SMOKE CONTROL DOOR || FDO-A10 MOTOR || VERT MNT || FACEMTD

JOB: CHOC HOSPITAL - TOWER II
CONTRACTOR: MCCARTHY
ARCHITECT: FKP ARCHITECTS
DISTRIBUTOR: MCKENDRY DOOR SALES

DRAWING NO. 0811040203

5 OF 38

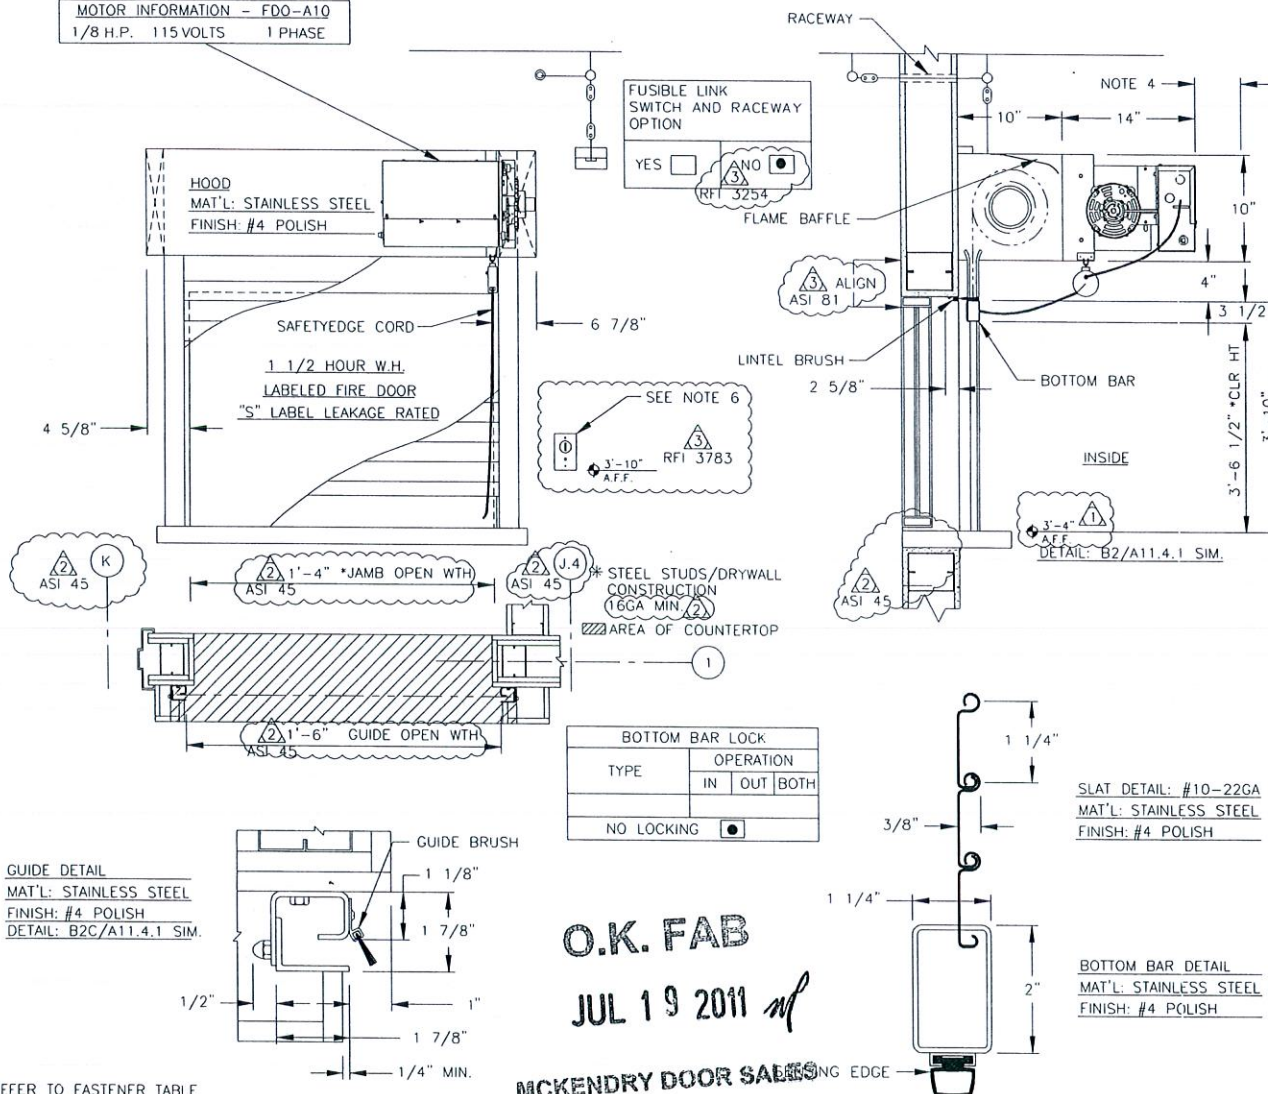
FAB PER Agreement w/McCarthy - SEE EMAIL

DRAWING NO. 0811040203 13 OF 38

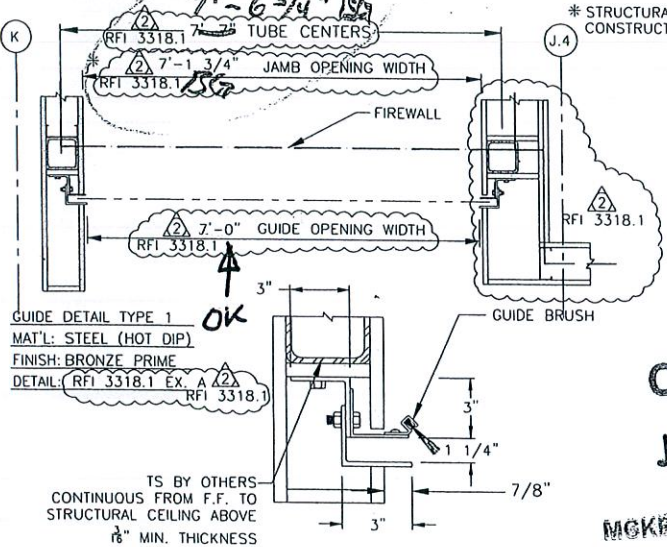
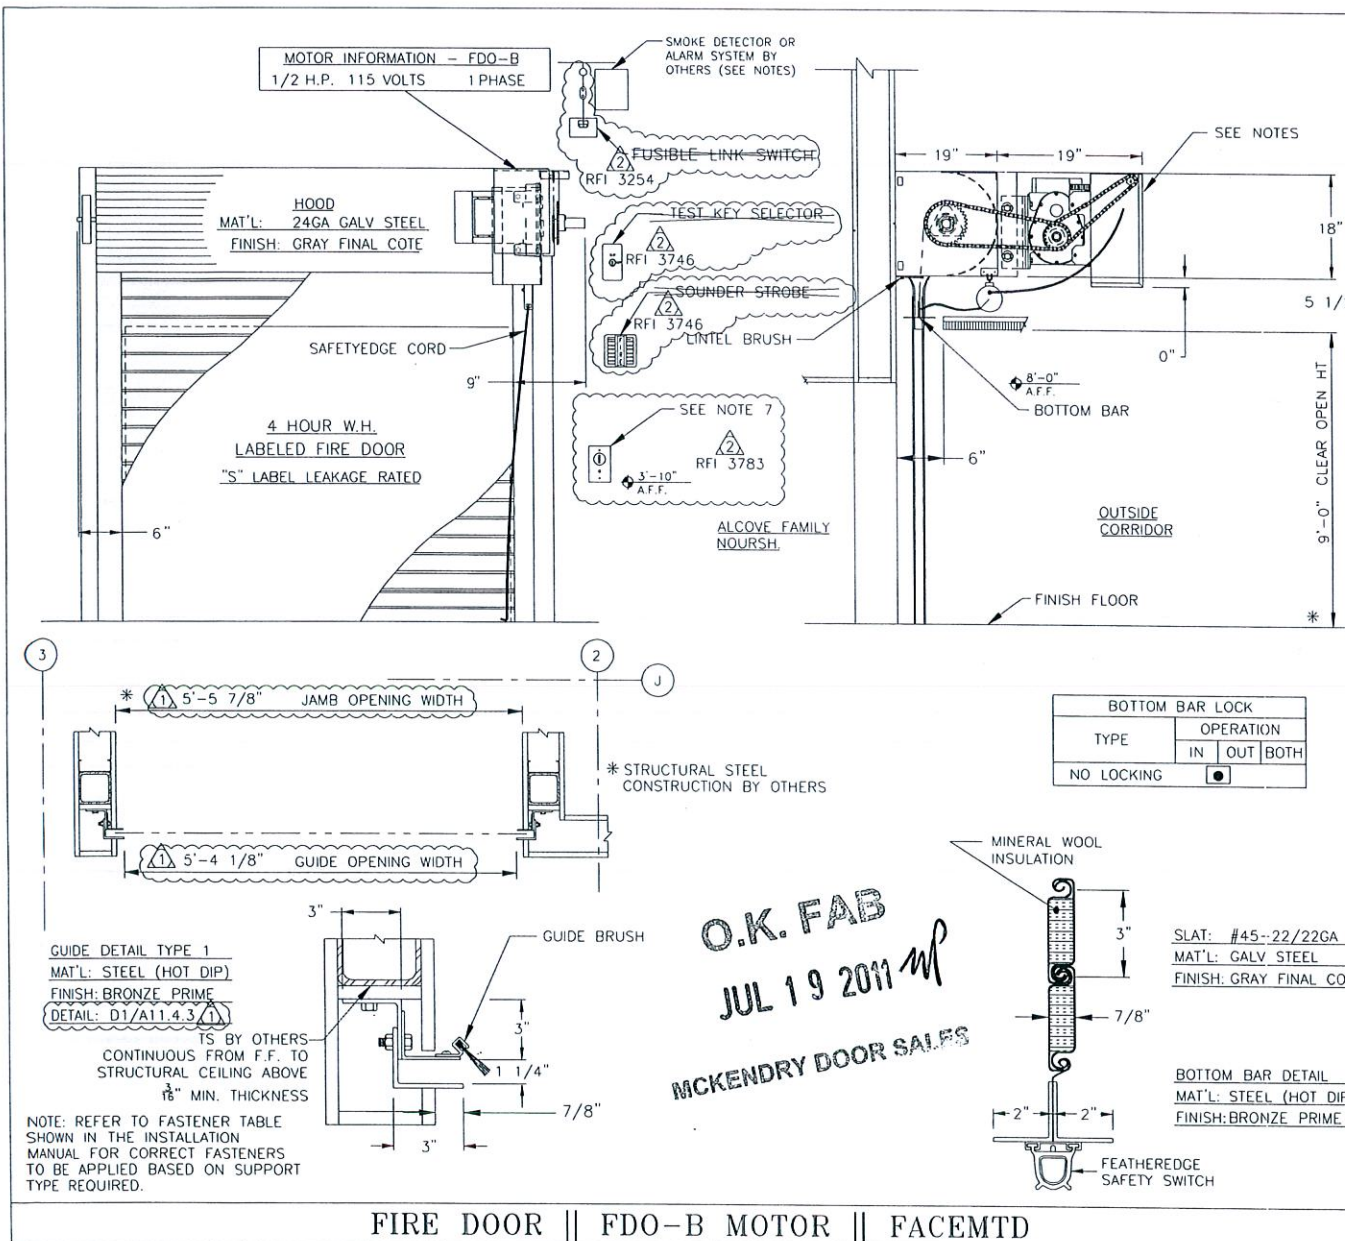
MOVE COPPER PIPE

all To Be moved per revision
6/16/11

G.C. TO
MOVE SPRINKLER

Reverse Handing
W/OLD RH

Copper Pipe

14" Sprinkler

15 OF 38

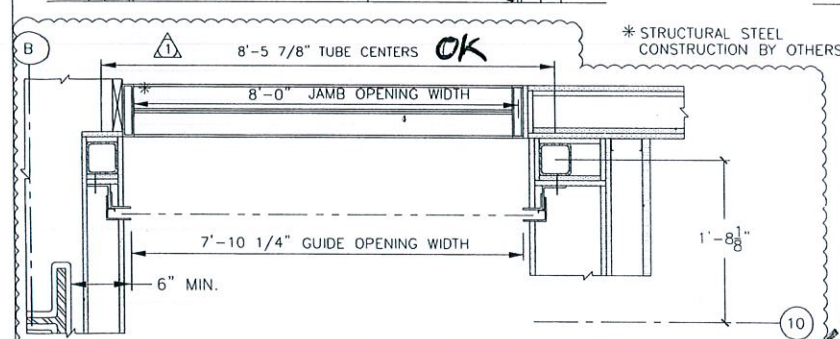
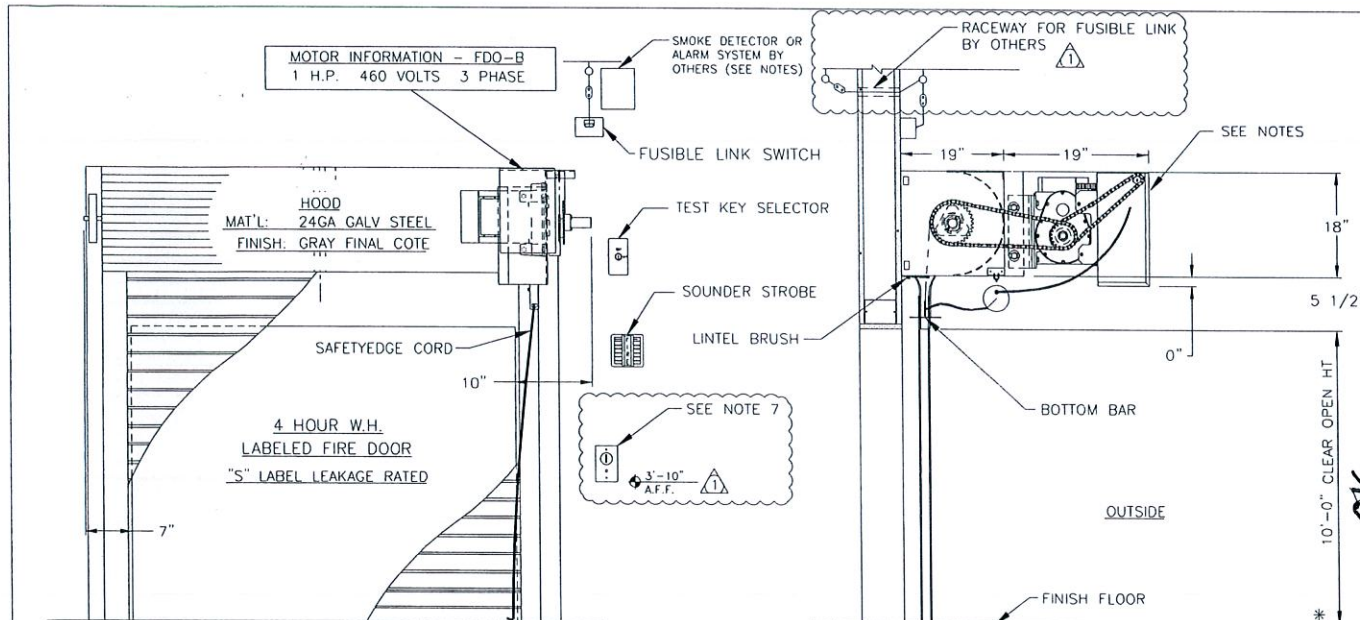
FAB PER AGREEMENT
w/ McCarthy - See Email

JOB: CHOC HOSPITAL - TOWER II
CONTRACTOR: MCCARTHY
ARCHITECT: FKP ARCHITECTS
DISTRIBUTOR: MCKENDRY DOOR SALES
DRAWING NO. 0811040203 25 OF 38

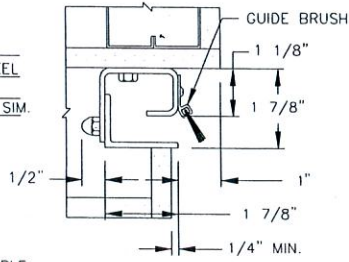
Pipe @ 11'2"
Emt @ 10'9" must move

Hard lid ceiling
(4" Stud) 5/8" Drywall
1/8" Tape mud

3 OF 38

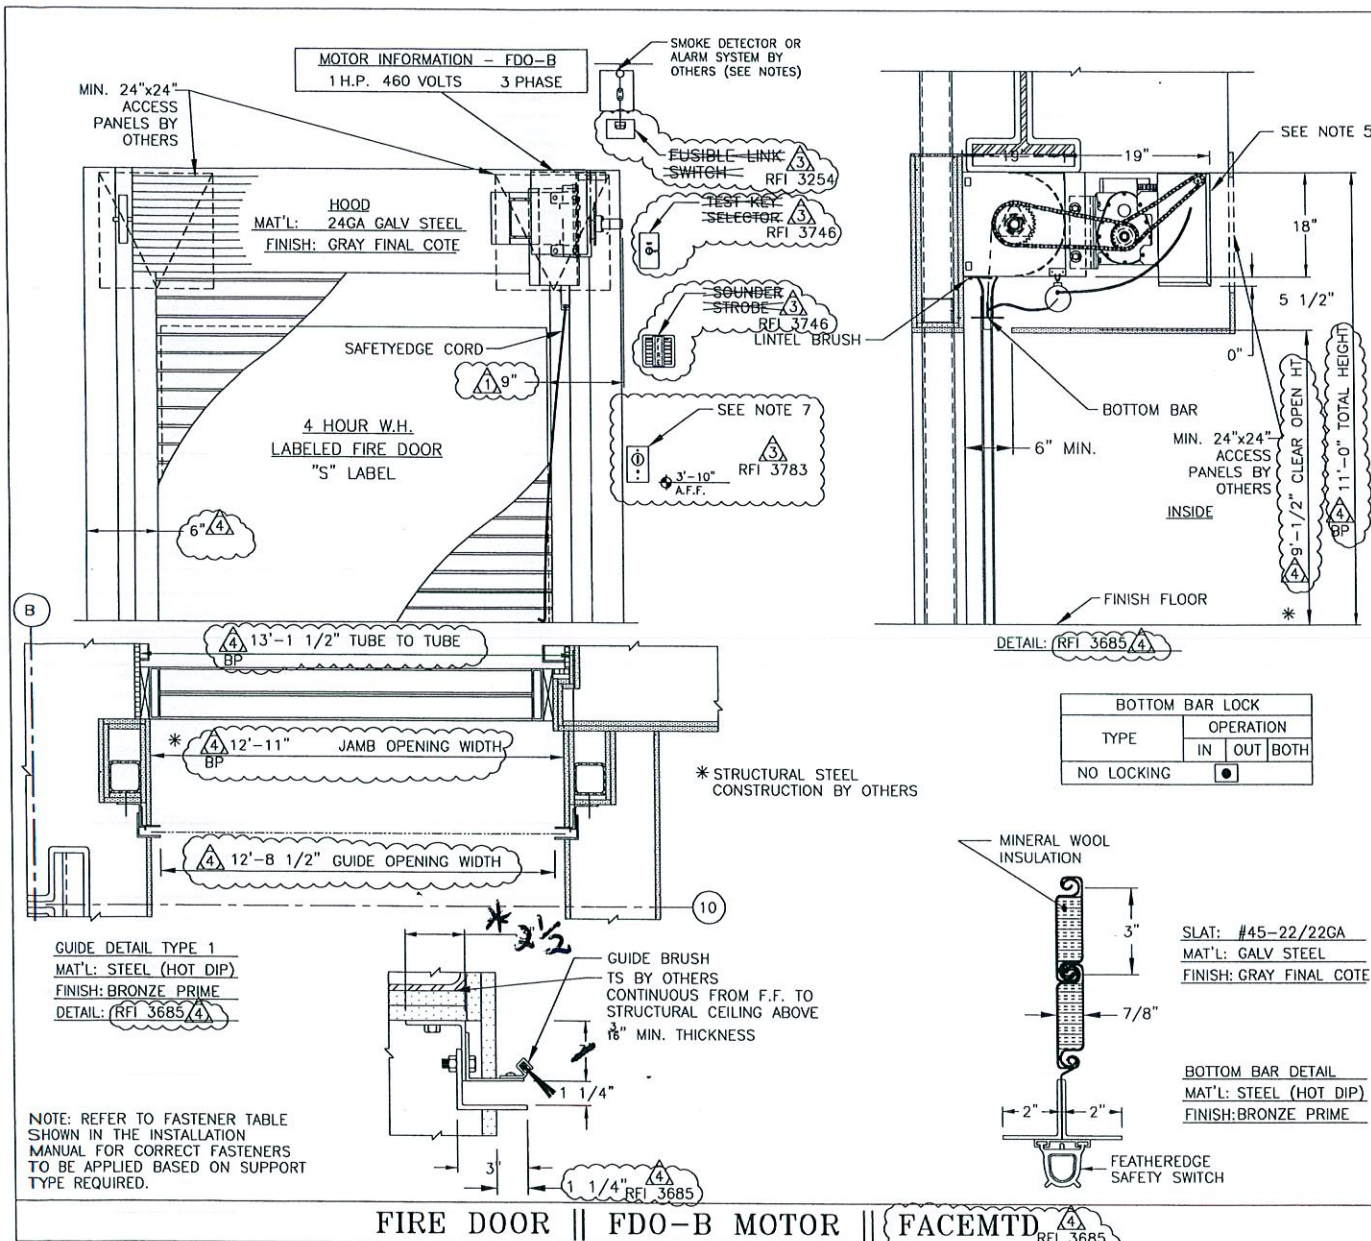
* HENZ WILL
PUSH BOLT OUT
2 1/2" IS STANDARD!

THIS USED TO BE R2

SB 08/17/11 PER FIELD VISIT / RFI 3685
